# UNITED STATES PATENT AND TRADEMARK OFFICE

APPLICATION NO.	FILING DATE	FIRST NAMED INVENTOR	ATTORNEY DOCKET NO.	CONFIRMATION NO.
09/437,296	11/09/1999	MICHIO YAMAJI	991283	7789

<b>Office Action Summary</b>	<b>Application No.</b> 09/437,296	<b>Applicant(s)</b> YAMAJI ET AL.	
	<b>Examiner</b> Aaron M. Dunwoody	<b>Art Unit</b> 3679

## DETAILED ACTION

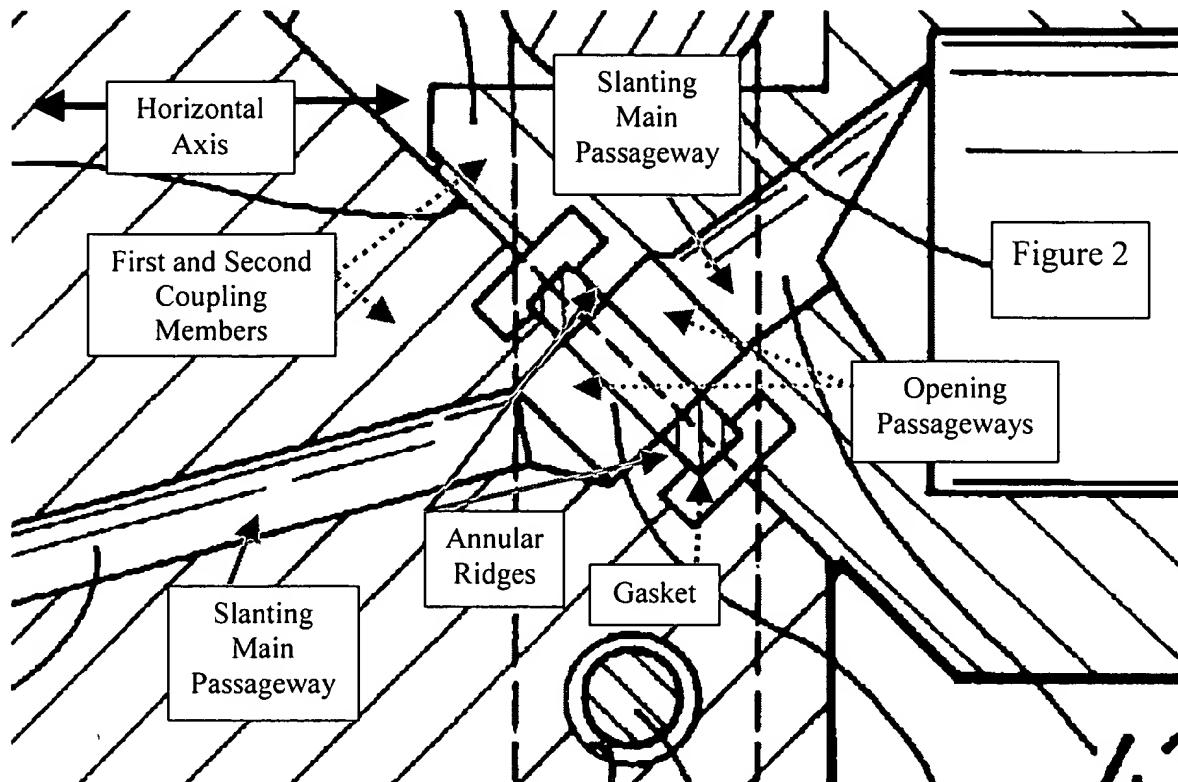
In regards to claim 1, in figure 2 below, Nakazawa et al discloses a fluid coupling comprising first and second coupling members having respective gasket holding annular ridges on butting end faces thereof; and

an annular gasket interposed between the first and second coupling members, wherein each coupling member has a fluid channel comprising an opening passageway orthogonal to the butting end face thereof, and a slanting main passageway communicating therewith, the opening passageway having a diameter equal to the inside diameter of the gasket holding annular ridge, and

the gasket holding annular ridges are in contact with the gasket at its radial midportion so as (capable) to relieve the inner peripheral portion of the gasket from stress concentration and wrinkles.

Nakazawa et al does not disclose the gasket holding annular ridges being rounded as to be in contact with flat, non-inclined faces of the gasket only at its radial midpoint. In Figure 5, Eidsmore teaches a gasket holding annular ridges (40) being rounded as to be in contact with flat, non-inclined faces of the gasket (42) only at its radial midpoint because this a relatively conventional arrangement well known in the art (col. 4, lines 24-26). As Eidsmore relates to pipe joints employing a metal gasket, it would have been obvious to one having ordinary skill in the art the time the invention was made to fabricate rounded gasket holding annular ridges as to be in contact with flat, non-inclined faces of the gasket only at its radial midpoint because this a relatively conventional arrangement well known in the art, as taught by Eidsmore.
